Errata #2

TO: All holders of the July 1992 edition of the Standard Plans Book

SUBJECT: Errata

The attached Revised Standard Plans (RSPs), New Standard Plans (NSPs) and Revised New Standard Plan (RNSPs) dated February 15, May 29, and August 28, 1996 contain revisions and additions to the July 1992 edition of the Standard Plans Book.

A=42 SQFT
TYPE VI ARROW
RIGHT LANE DROP ARROW
(FOR LEFT LANE, USE MIRROR IMAGE

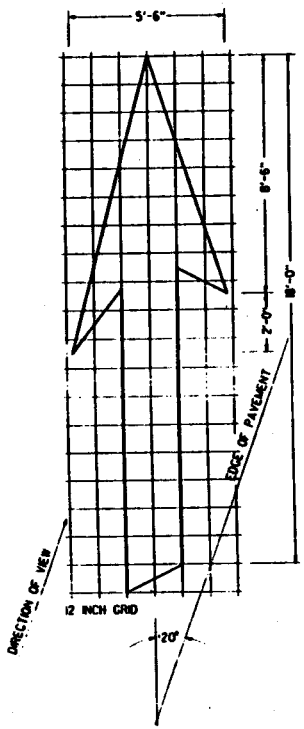
RSP A24A, " Pavement Markings-Arrows", revises the configuration of the Type VI Arrow (Right Lane Drop Arrow) and includes a new details for the Bike Lane Arrow.

REVISED STANDARD PLAN RSP A24C

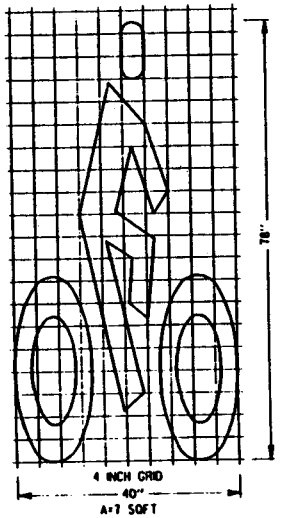
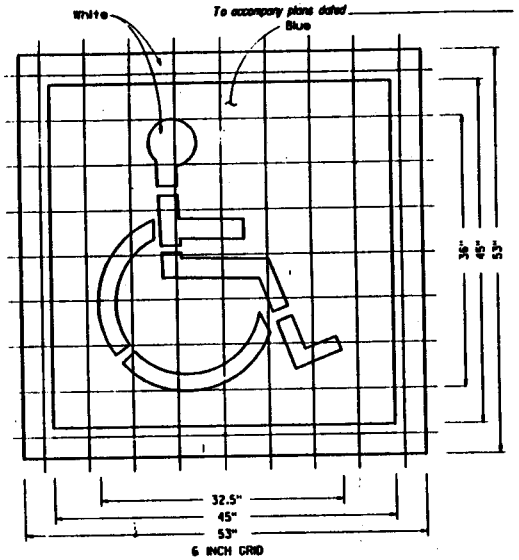
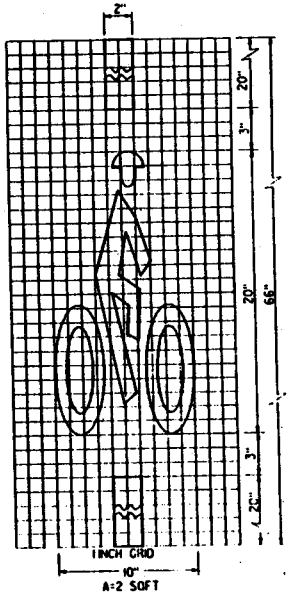
RSP A24C, " Pavement Markings-Symbols and Numerals", revises the details for the Bike Lane Symbol and the Handicapped Parking Symbol and includes a new detail for the Bike Loop Detector Symbol.

REVISED STANDARD PLAN RSP A75B

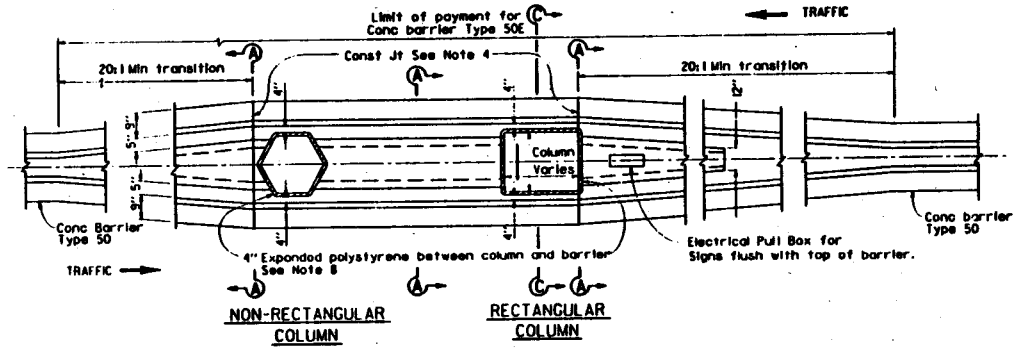
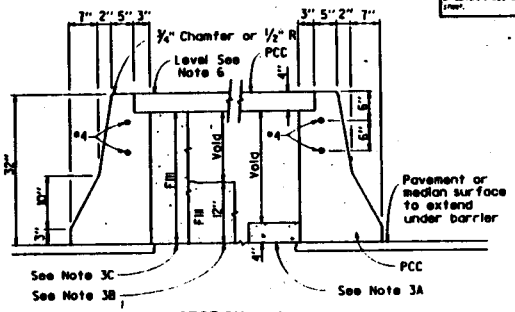
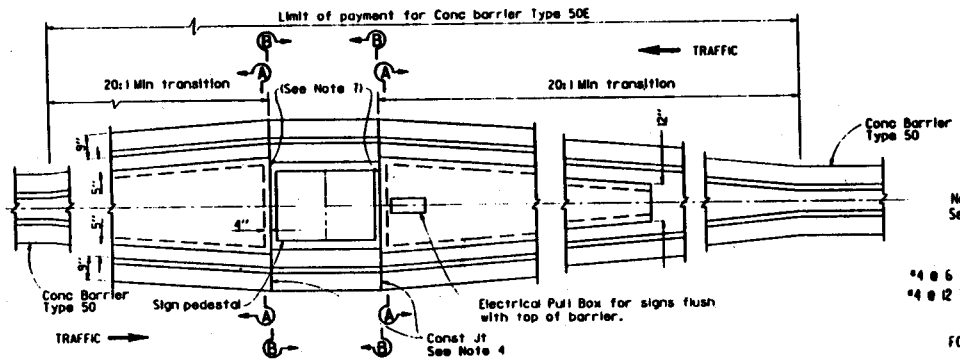
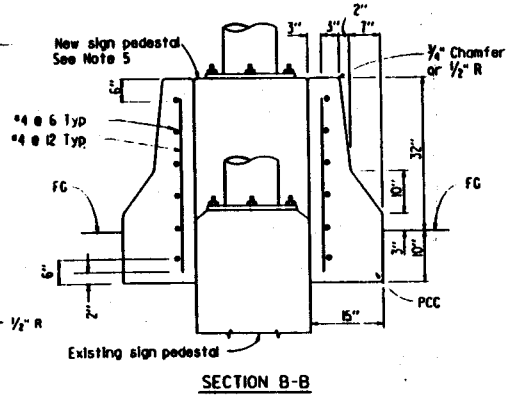
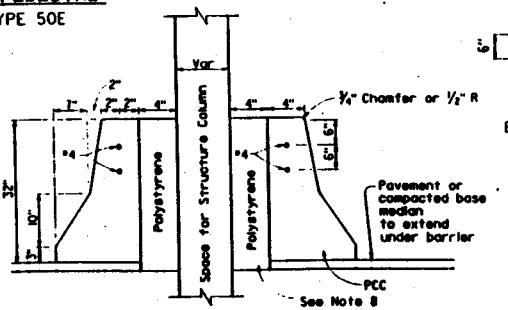
RSP A75B, " Concrete Barrier Type 50E", is revised to increase the thickness of the expanded polystyrene which encloses the columns to 4 inches.

REVISED STANDARD PLAN RSP A77D

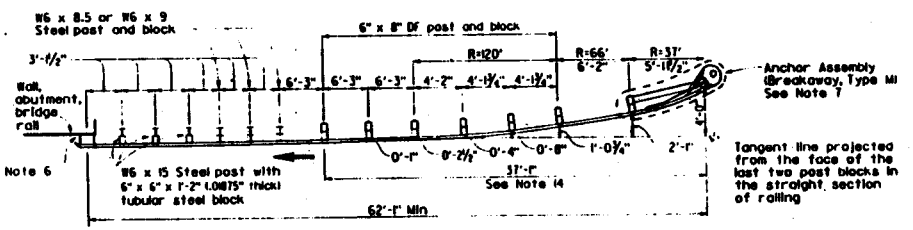
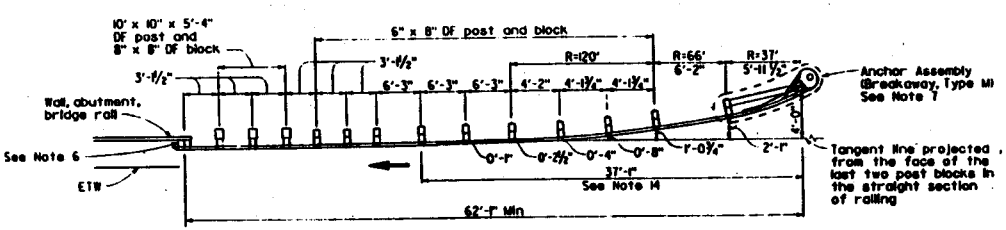
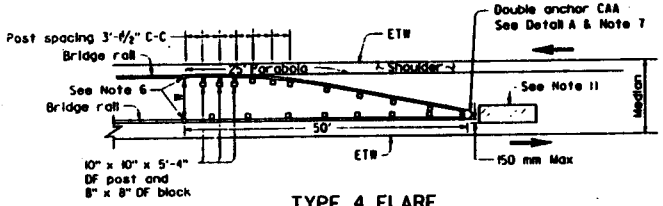
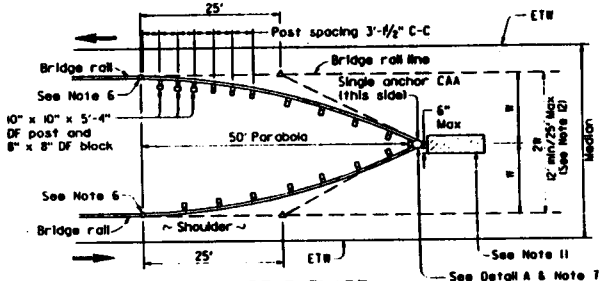
RSP A77D, RSP A77E, RSP A77F, RSP A77G, RSP A78C and New Standard Plan NSP A77GA, provide for the use of new Type M breakaway end anchors for new Type 1M and Type 8M flares used with metal beam guard railing. Type M breakaway anchor assemblies replace Type A breakaway cable anchor assemblies. Type 1M and Type 8M flares replace Type 1 and Type 8 flares, respectively. In addition to the revisions on RSP A77D for the use of Type M breakaway anchor assemblies, the Type 2 flare has been deleted.

REVISED STANDARD PLAN RSP A87

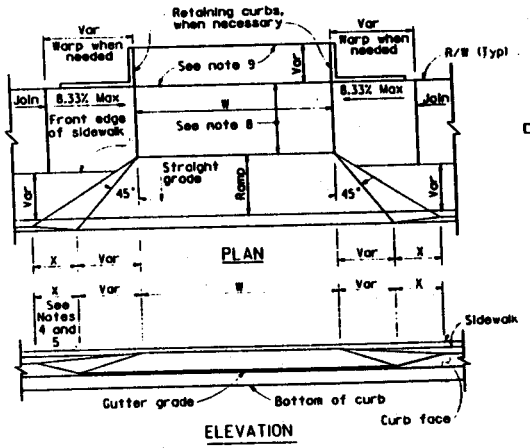
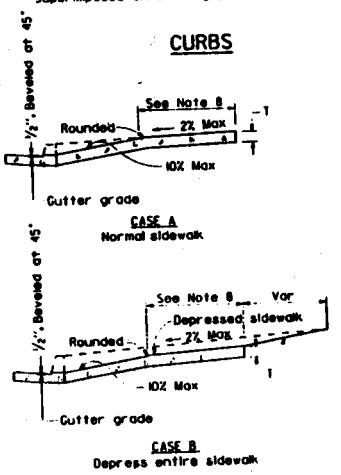
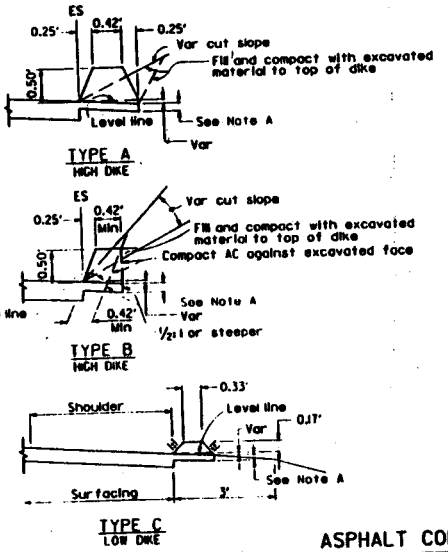
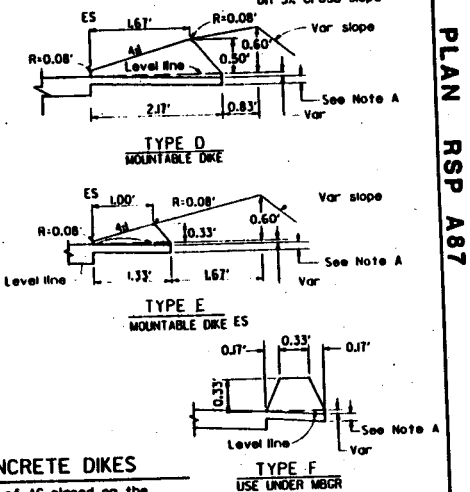
RSP A87, " Curbs, Dikes and Driveways", provides a new detail for Asphalt Concrete Dike, Type F. Type F dike is used when asphalt concrete dike is placed under metal beam guard railing.

REVISED NEW STANDARD PLAN RNSP A88

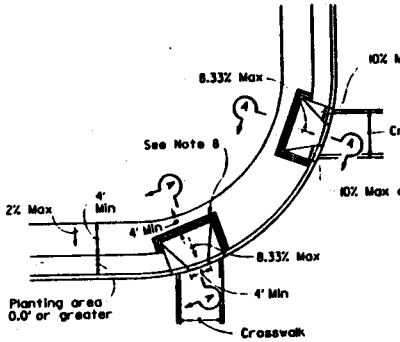
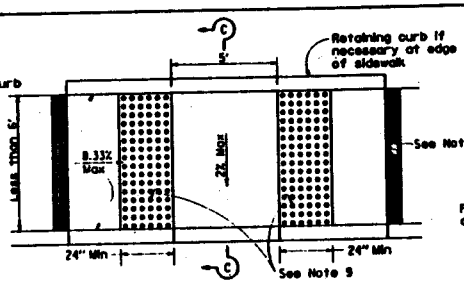
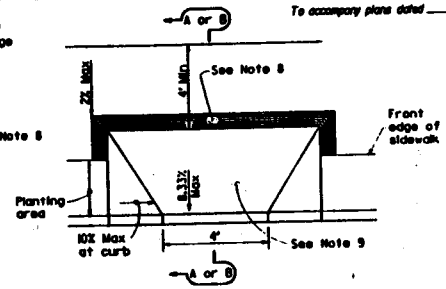
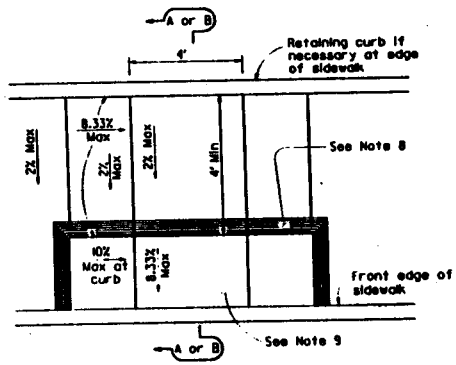
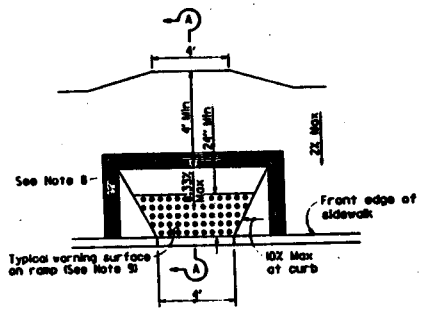
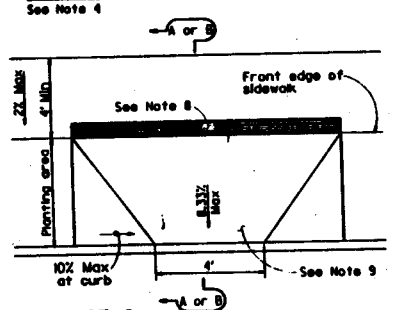
RNSP A88, " Curb Ramp Details", provides curb ramp designs which comply with the Americans With Disabilities Act requirements and which have been approved by the Division of the State Architect. The curb ramp designs shown on RNSP A88 supersedes all prior curb ramp designs including those contained in NSP A88 dated 7-01-92 and the construction detail sheets issued by P.K. Griffin's memorandum of June 15, 1994.

NEW STANDARD PLAN NSP A90

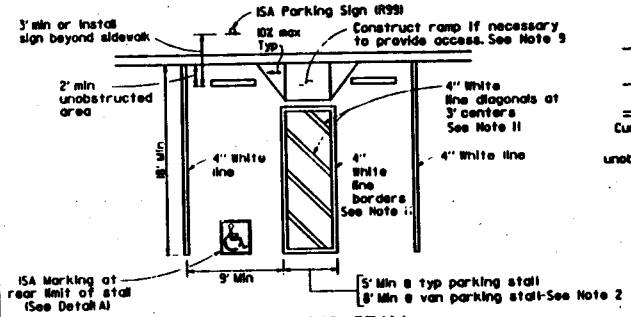
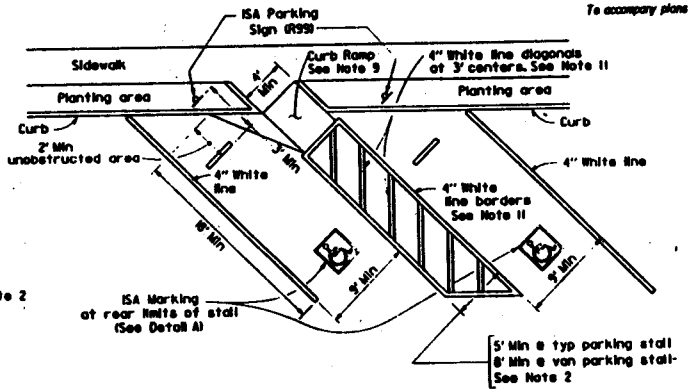
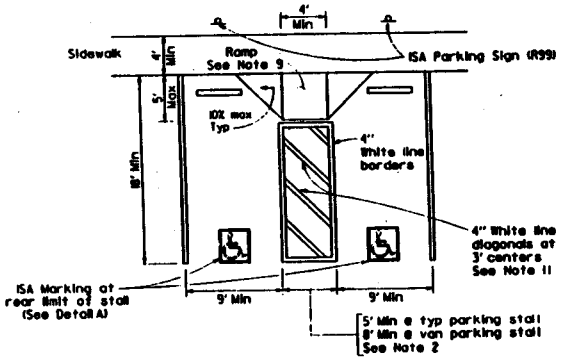
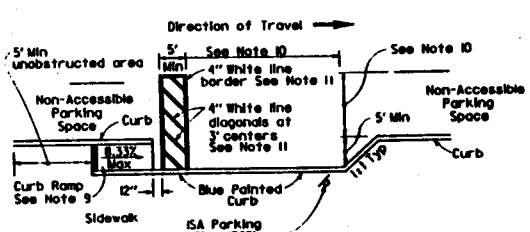
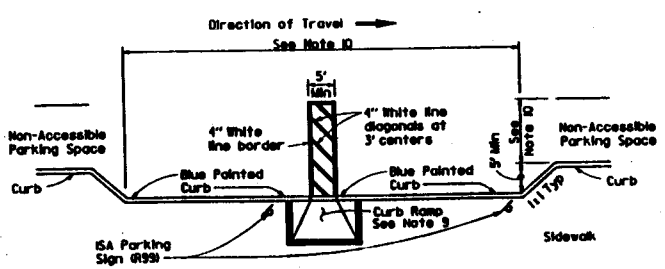
NSP A90, " Accessible Parking", provides accessible parking details which comply with the Americans With Disabilities Act requirements and which have been approved by the Division of the State Architect. The accessible parking details shown on NSP A90 supersedes all prior accessible parking details including those contained in the construction detail sheets issued by P.K. Griffin's memorandum of June 15, 1994 .

REVISED STANDARD PLAN RSP T2

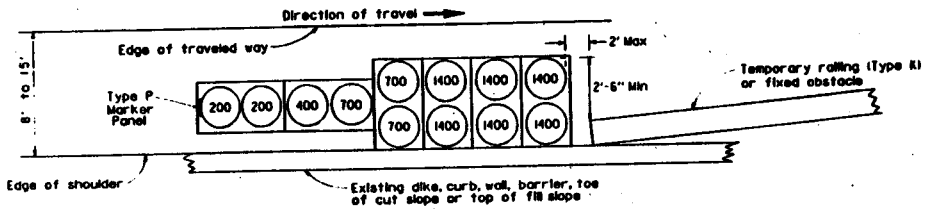
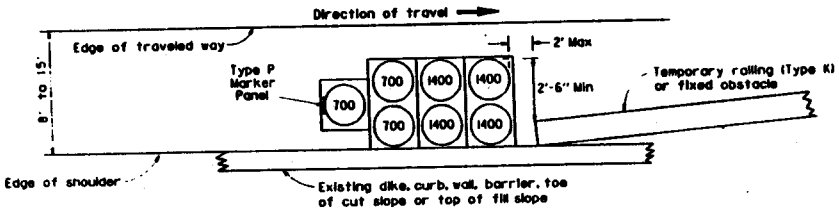
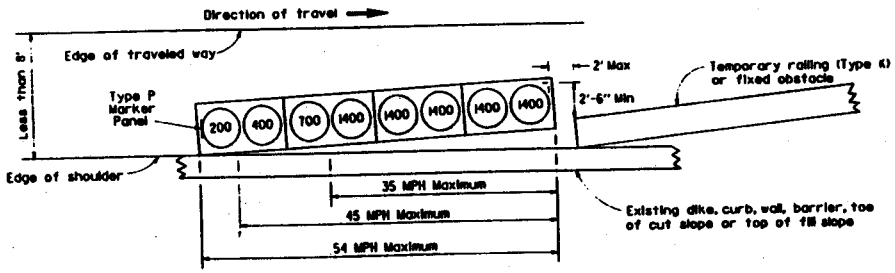
RSP T2, "Temporary Crash Cushion-Sand Filled", revises the plan sheet by deleting temporary crash cushion array "TI".

NEW STANDARD PLAN NSP T5

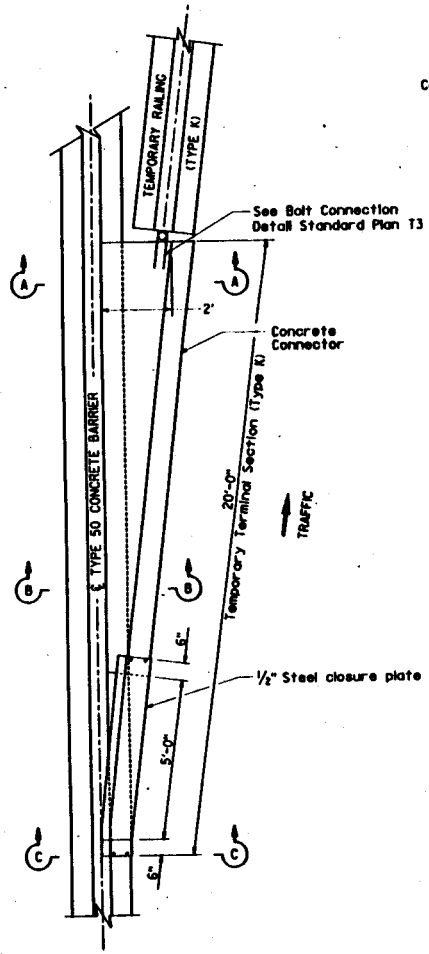
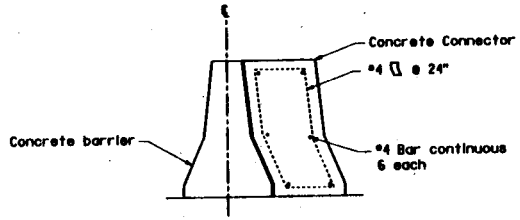
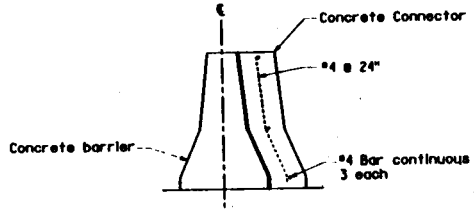
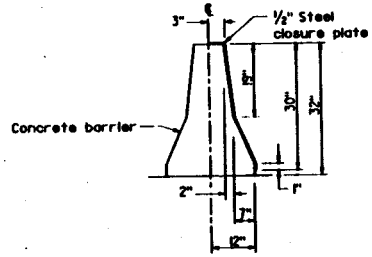
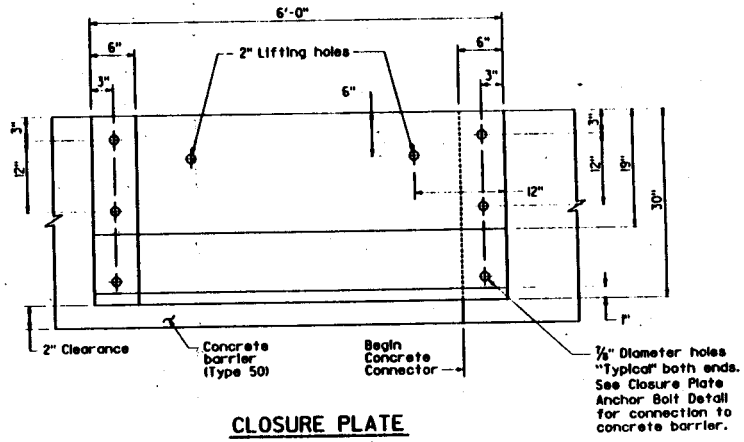
NSP T5, " Temporary Terminal Section (Type K)", provides details for attaching temporary railing (Type K) to concrete barrier (Type 50). It eliminates the need for sand barrel energy attenuators at the end of temporary railing (Type K) when used in conjunction with safety-shaped concrete barriers.
